SIDE AND REAR DECK PLAN

OVERLY RESIDENCE
913 SOUTH HANCOCK ST.

22-VARIANCE-0076

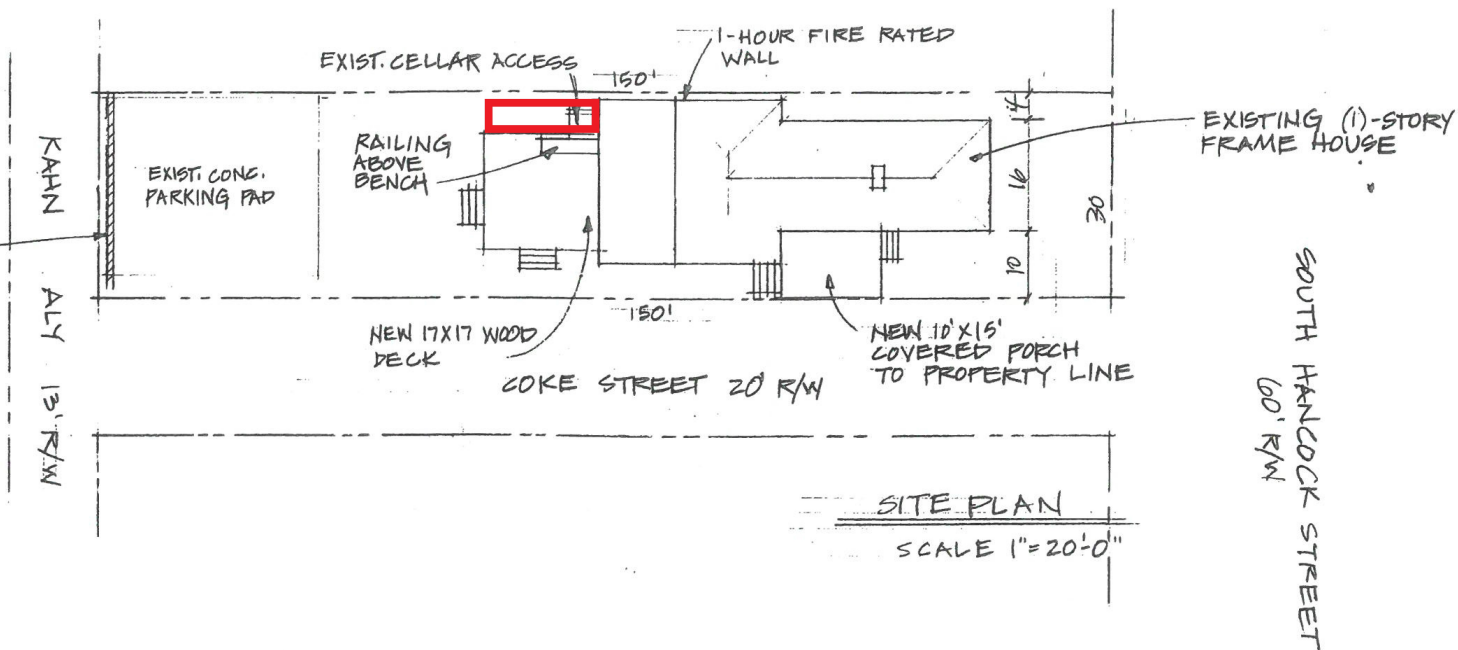
RED BOX is the requested **MODIFIED VARIANCE**.
The crawl space was consistently being broken in to.
Further canceling the crawlspace entry would invite
more break-ins.
